ABU GHRAIB DAIRY  
ABU GHRAIB, IRAQ

**SIGIR PA-09-172**  
**JANUARY 14, 2010**

## Abu Ghraib Dairy

SUBJECT: Report on the Abu Ghraib Dairy, Abu Ghraib, Iraq  
(SIGIR Report Number PA-09-172)

**Figure 2. Primary truss configuration**

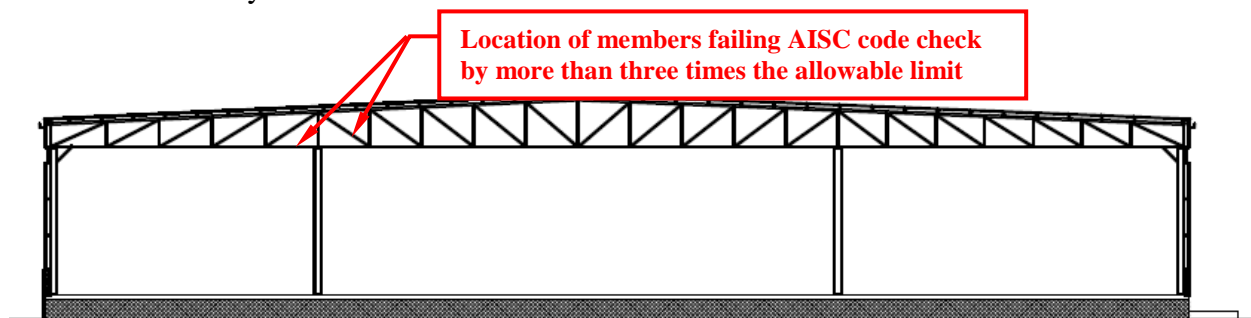
- Based on the contractor's calculations, five members of the truss were designated as failing the AISC code check. Two of the members failed the code check by more than three times the allowable limit (Figure 2). Failing by a factor of this magnitude indicates that the members could yield and possibly fracture under the design load.

The contractor's proposed structural design consists of steel columns and continuous truss construction with sandwich panel cladding<sup>18</sup> for the roof and sidewalls. Roof loads are carried by the multi-span steel trusses, which have two configurations. The primary configuration has steel columns supporting the truss at the ends and at approximately one-third span (Figure 2). The columns are centered on a truss panel point (the location of intersecting truss members), which is appropriate. Based upon the contractor's drawings, it appears that the member sizes have been modified to accommodate the stress reversal<sup>19</sup> over only one of the interior columns.

**Figure 3. Truss configuration at mezzanine level**

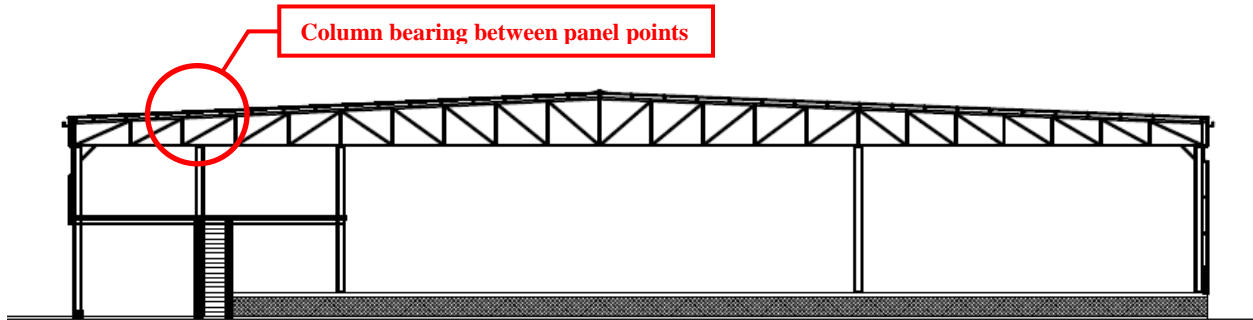
In the area of the mezzanine, the plans show additional columns (Figure 3), which extend through the mezzanine to the underside of the truss. The additional bearing locations provided by these columns are not at a truss panel point. The resulting reactions from these columns will introduce bending into the lower chord of the truss. SIGIR is

concerned that the members used in the lower chord of the truss are relatively light and do not appear to have the capacity to resist a significant amount of bending stress in addition to the compressive load that will result from the intermediate support.

**Figure 4. Knee brace detail**

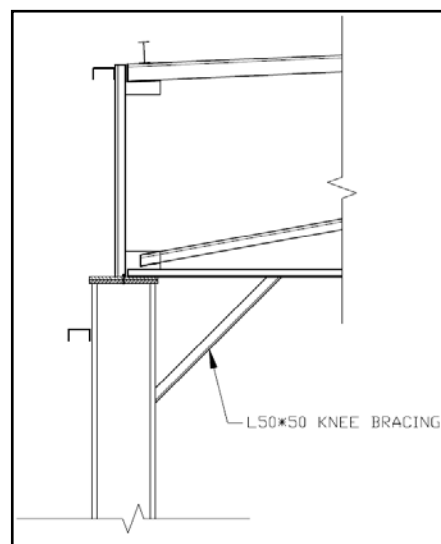
The contractor's design drawings do not address the method used to resist lateral loads parallel to the building's gable. It appears that the design incorporates diagonal cross bracing between several bays in the direction parallel to the ridge; however, there is no indication of bracing parallel to the gable (slope). In addition, the building's use of column and truss construction requires additional consideration of lateral loads. The only members that appear to be placed to provide lateral stability in the axis of the gable are the diagonal knee braces (Figure 4). These knees appear to be severely undersized, considering their location and configuration.

If the braces are used to resist lateral loads, the connection between the columns and truss would become, at least, partially fixed. This would introduce significant load into the lower chord of the truss, which appears to be already undersized. Fixing the truss/column connection would also introduce a lateral component into the column reaction; special consideration would then be required in the design of the foundation to resist this load.

**Site Photo 1. Typical foundation pedestal and anchor bolts**

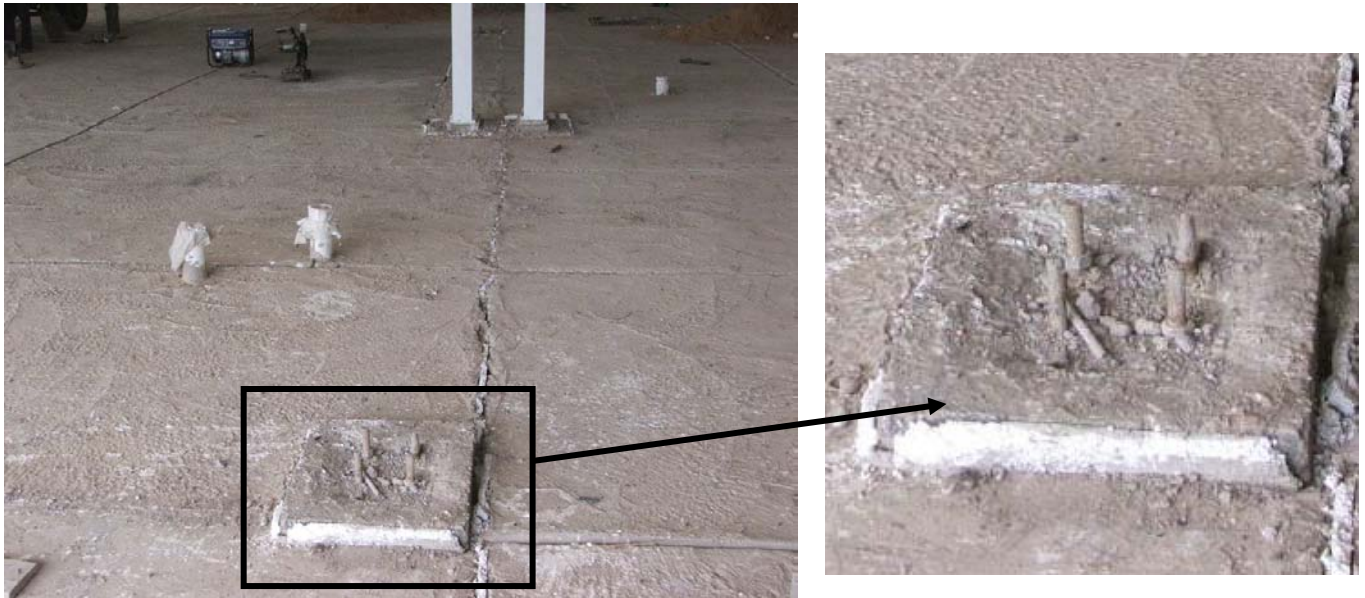
At the time of the site visit, the foundations for the facility were installed. The foundation system appeared to be concrete pedestals with steel anchor bolts attached to the base plates of the steel columns (Site Photo 1). The foundation system also included spread footings to support the concrete pedestals and columns. Since the foundation was in the later stages of construction, only the upper portion of the foundation was exposed for inspection; consequently, SIGIR could not verify the construction of the foundation.

**Site Photo 4. Cross brace conflict with CMU perimeter wall**

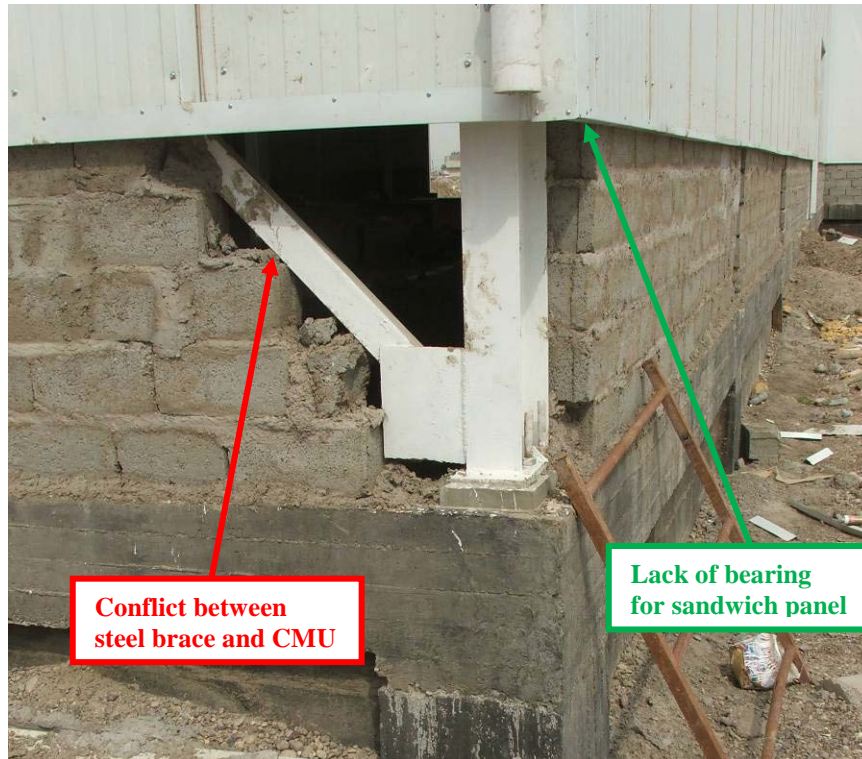
The CMU wall interferes with the steel cross bracing between several of the columns (Site Photo 4). It appears as if the contractor's solution to this issue was to lay the CMU wall around the bracing and coat the entire area with plaster. However, this approach may cause future problems as the steel bracing moves independently of the CMU wall causing recurrent cracking at the location.

Previously, SIGIR noted that due to the contractor's deviation from the design drawings, the steel cross bracing for the structure conflicted with the CMU perimeter wall. To correct this, the contractor removed the CMU wall, relocated the steel cross bracing to the interior of the wall, and reconstructed the wall (Site Photos 19 and 20).

**Site Photo 5. Course of CMUs placed with cores horizontal**

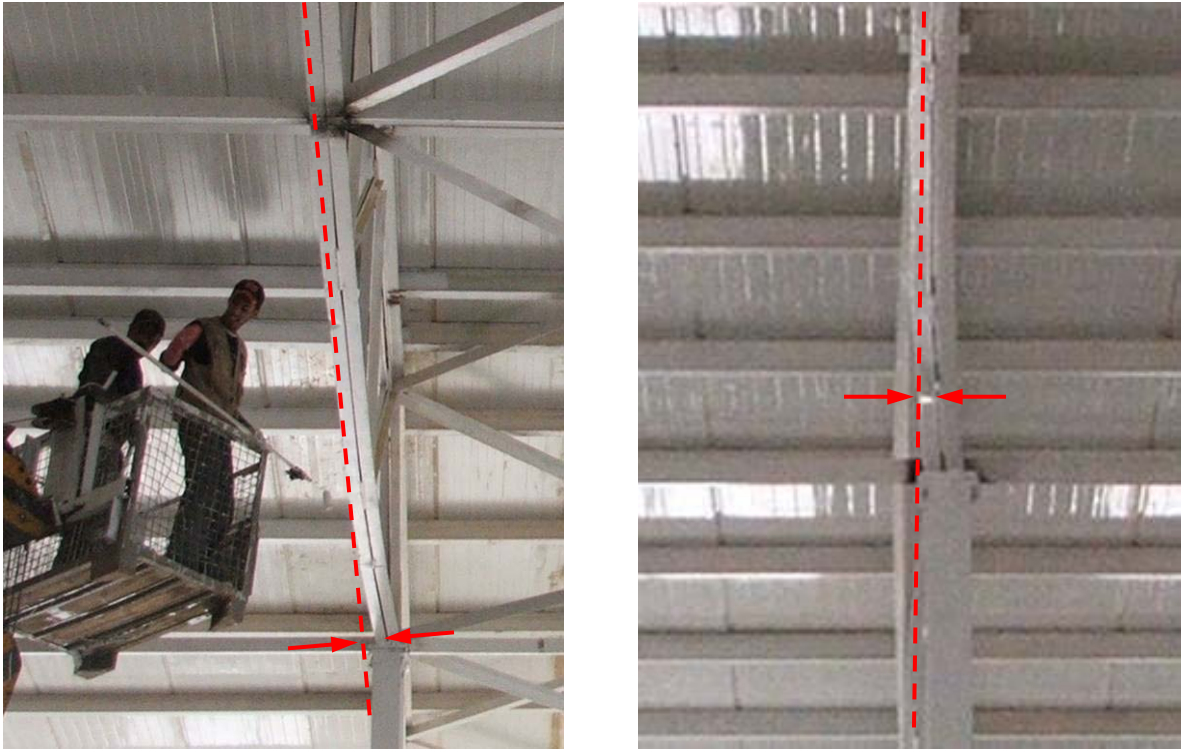
SIGIR also noticed several areas where one course of CMUs was laid on their sides (cores horizontal) (Site Photo 5). The detailed plans did not show this type of construction technique and it is unclear why the contractor did this. SIGIR's concern is that CMUs are significantly weaker when placed in this orientation. If these CMUs are intended to support the weight of the loaded floor slab, additional reinforcement of this area is needed.

The quality of the construction of the floor slab was very poor and appeared to have been poured without the correct tools or equipment. The slab has high and low spots in various places and raised tool marks from what appears to be preliminary leveling of the

slab. There is no indication that final finishing was performed after preliminary leveling. The slab's inconsistency may create problems for forklift traffic and future equipment installation.

**Site Photo 18. Contractor's truss modification**

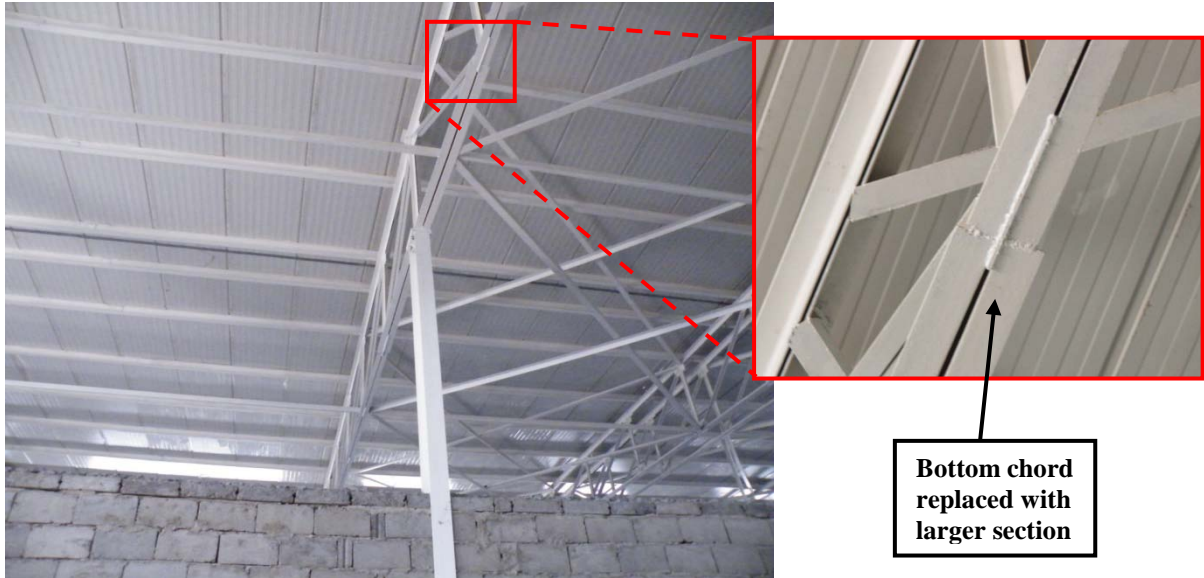
In order to remedy the deformation of the roof trusses SIGIR previously identified, the contractor's modification included the removal of the lower truss chord in the area where

it was inadequate and replaced it with a larger section. Aerial lift capabilities were not available at the time of the site visit; therefore, a hands-on inspection of the repair could not be made. However, SIGIR was able to verify that the trusses had a larger bottom chord section in the areas previously noted as deficient (Site Photo 18).
